Appl. No. : 09/853,998
Filed : May 21, 2001

REMARKS

FIG. 1 (Prior Art)

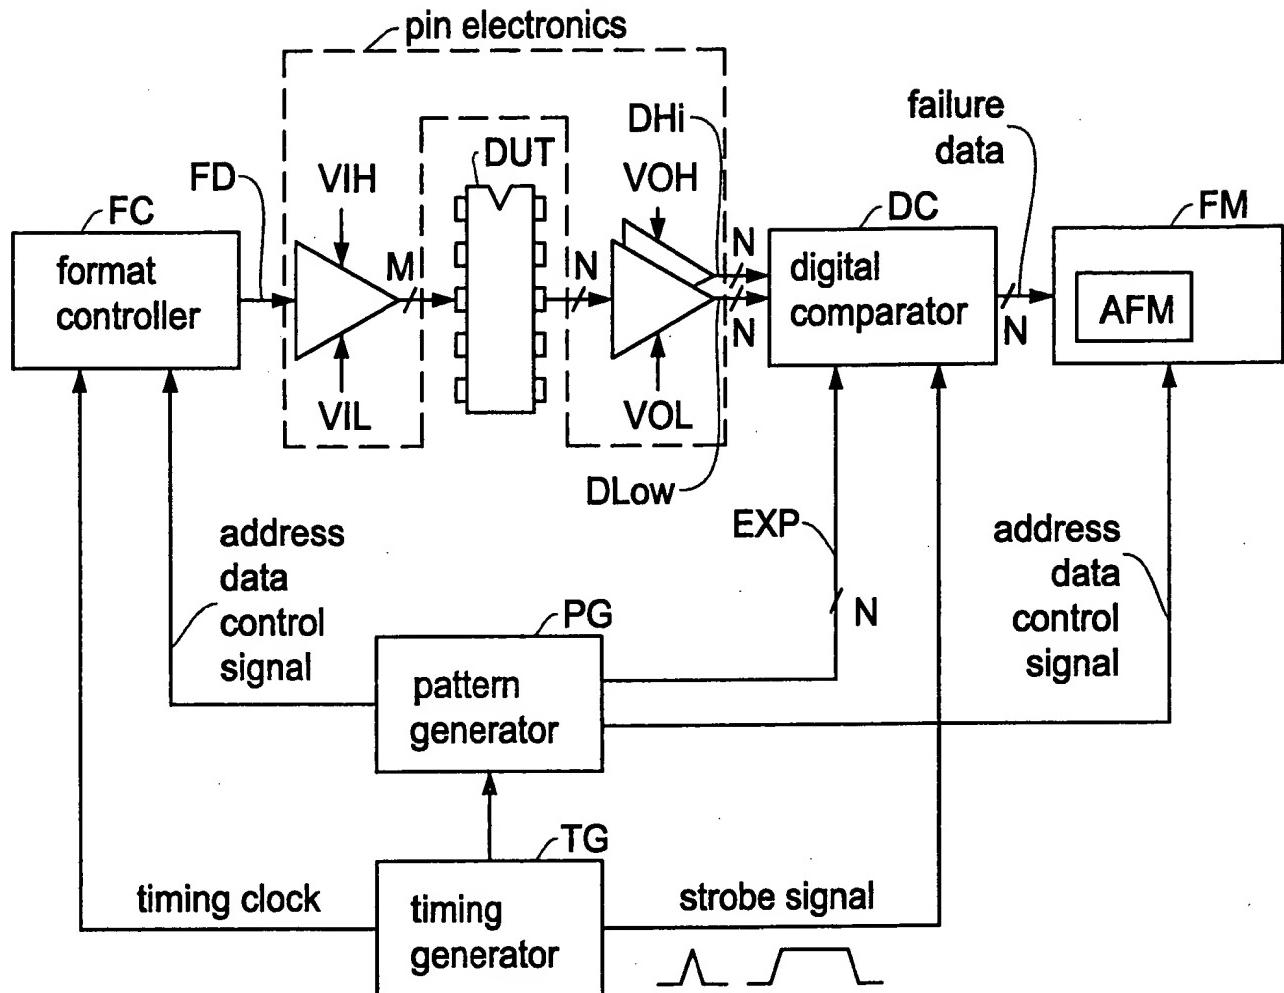
In the Office Action, the examiner objected to the drawings on the ground that Figures 1 and 2a lack prior art legends. Accordingly, the applicant has submitted concurrently herewith a request for approval of drawing changes in which a "Prior Art" label is added to Figures 1 and 2a. Replacement sheets of Figures 1 and 2a are also enclosed.

The applicant has submitted concurrently herewith a request for approval of drawing changes in which a "Prior Art" label is added to Figures 1 and 2a to overcome the objection to the drawings by the examiner.

FIG. 2A (Prior Art)

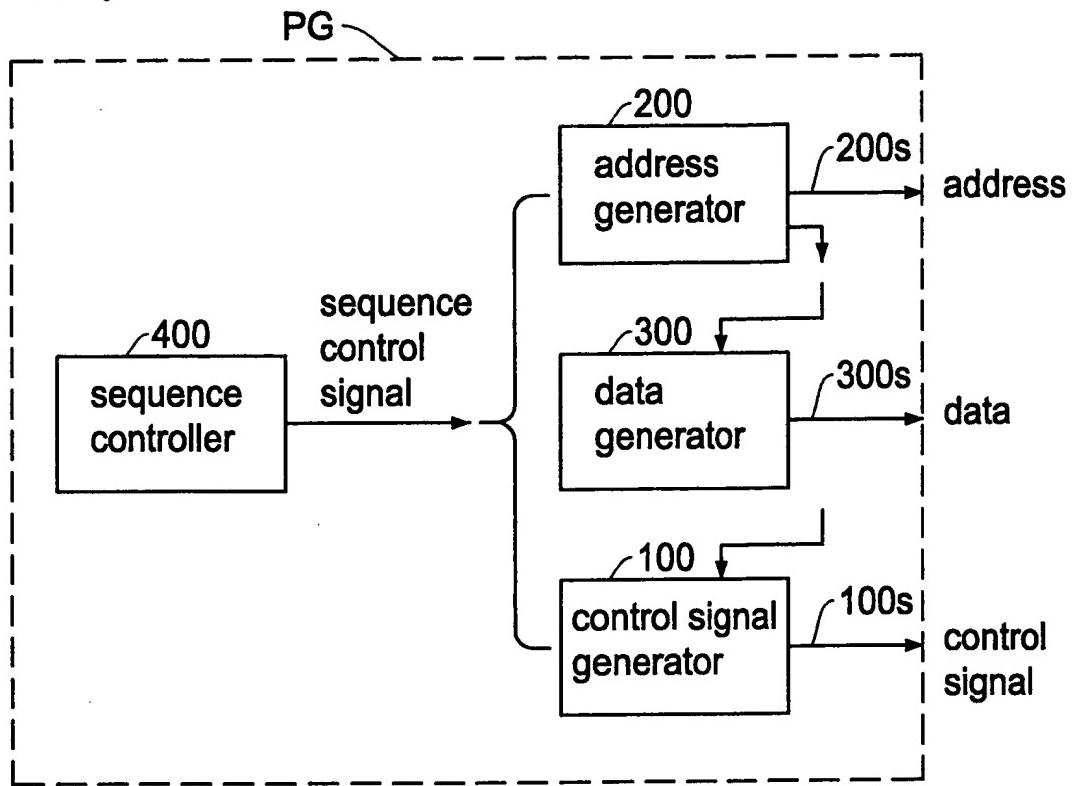
With respect to the latter part of the rejection under 35 U.S.C. 112, second paragraph, regarding how the test patterns will be generated when the memory under test has different row and column sizes or when the left and right hand sides of the equation do not match with one another, it appears that the examiner misunderstands the operation of the pattern generator. The test pattern for memory testing are generated by the pattern generator

of Figure 2A. The test pattern includes address data, control data and write data. Regardless of the row and column sizes or mismatch of the equation, the test pattern is generated by simply changing the address data for sequentially accessing the memory cells while providing the same write data such as "1". The inversion request signal of the present invention is used to invert the write data (from "1" to "0" for example) for only the predetermined memory cells accessed by the address data. In other words, the operation for generating the test pattern is not affected by difference of the row and column sizes of the memory device under test or the mismatch of the right and left sides of the equation.
